P&Z STAFF REPORT Board of Appeals Meeting, April 2, 2025

Case: **V-24-36 – 265 Skyridge Drive**
Staff Contact: LaQuita Williams (lwilliams@sandyspringsga.gov)
Report Date: March 27, 2025

Request for a variance from Section 7.8.24. to allow for a detached garage to be located within the 40-foot side street setback and to exceed the height and size requirement.

SITE PLAN

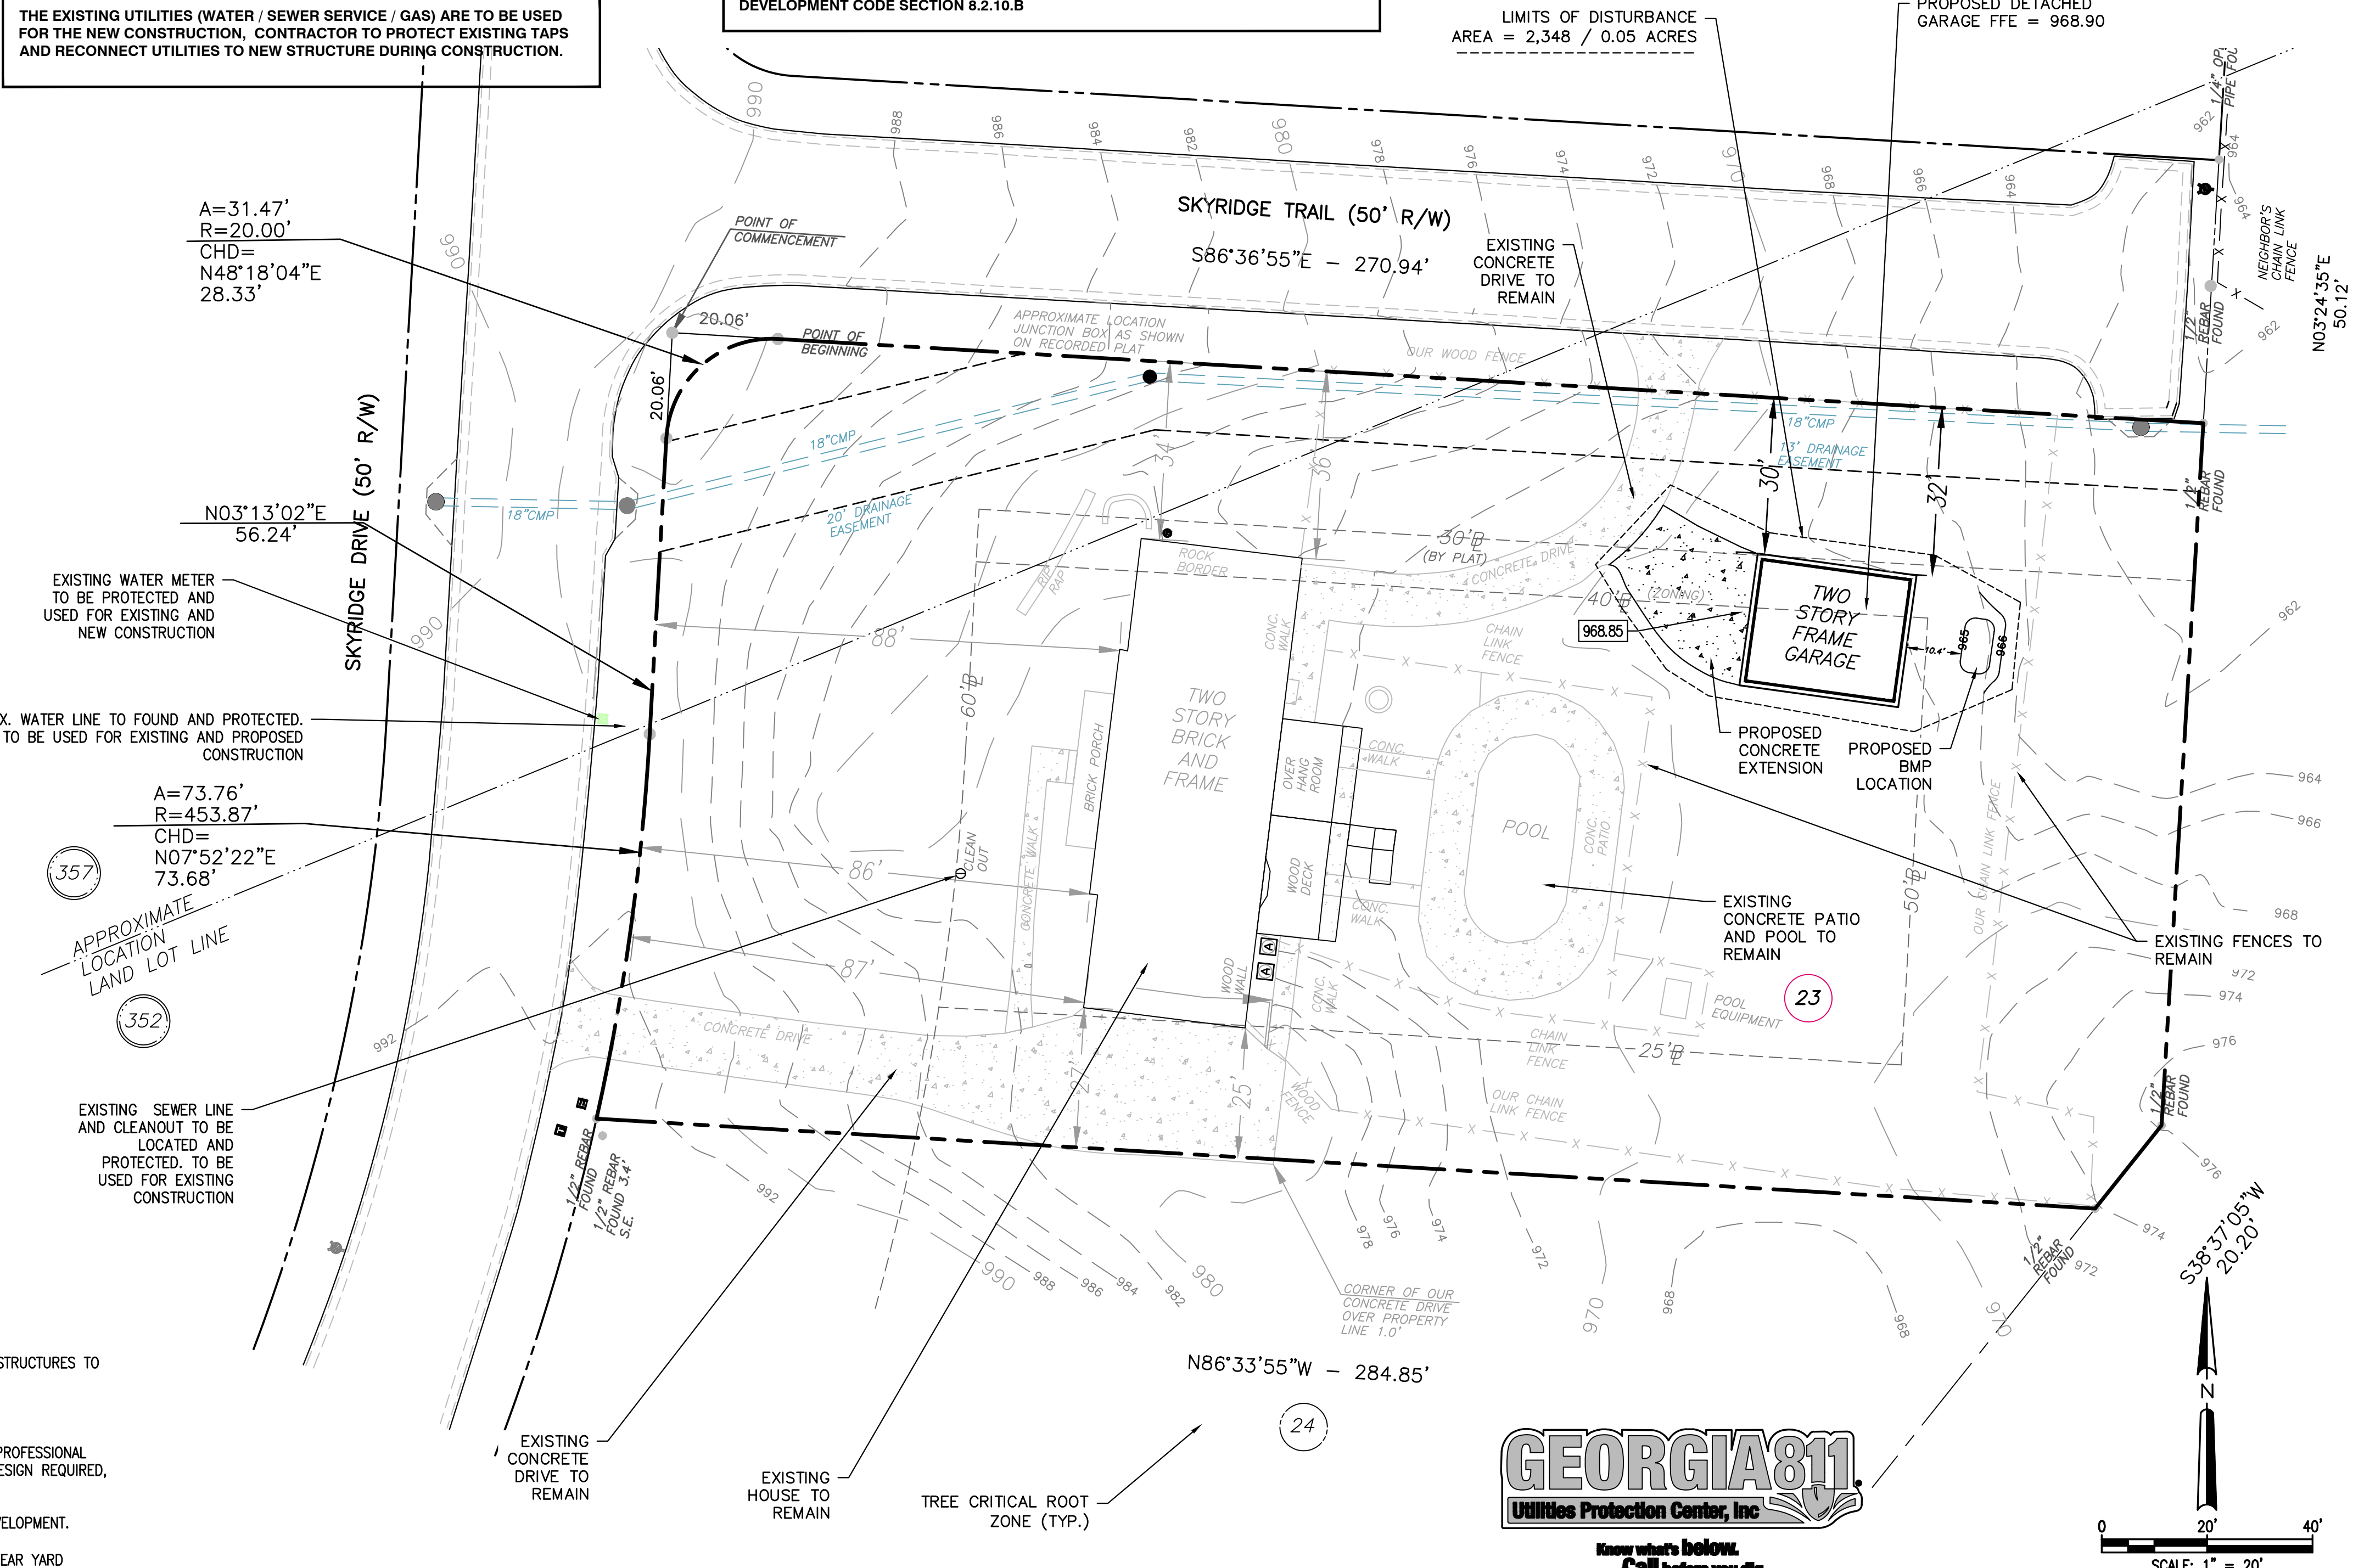
1) The septic drain lines could be relocated to accommodate the garage within the buildable area.
2) The magnolia tree adjacent to the constructed garage is a Landmark Tree. The construction of the garage impacted more than 25 percent of the critical root zone of the tree; therefore, the tree is considered lost and Landmark mitigation is required. Two 2.5" caliper large canopy trees are required to be replanted. Additionally, as the magnolia tree is located within the side setback of the property, side setback tree mitigation is required (see Section 9.4.2.G). One 2" caliper large canopy tree is required to be replanted.

3. Show the septic field on the Site Plan, since that is part of the justification for the variance.
3. Suggestion (since we do not see the septic field on the plans): Slide the new garage in behind the pool by ten additional feet, and then a variance will not be required. Then design a more aesthetically appealing garage so that it will enhance the pool area. Maybe add a covered porch facing the pool, or at least an arbor.

4. Suggestion: Add some sort of roof over the garage doors and the pedestrian door to reduce weather damage.
5. Note: The existing pool enclosure is apparently a chain link fence. Please note that traditional chain link fence is not compliant with the International Swimming Pool & Spa Code, since it is climbable.

1. Screen the garage from Skyridge Trail with trees approved by the Arborist;
2. Pool enclosure shall comply with the International Pool and Spa Code;
3. Install a moderately enhanced landscape strip along Skyridge Trail approved by the Director and,
4. Construction must be substantially similar to site plan provided.
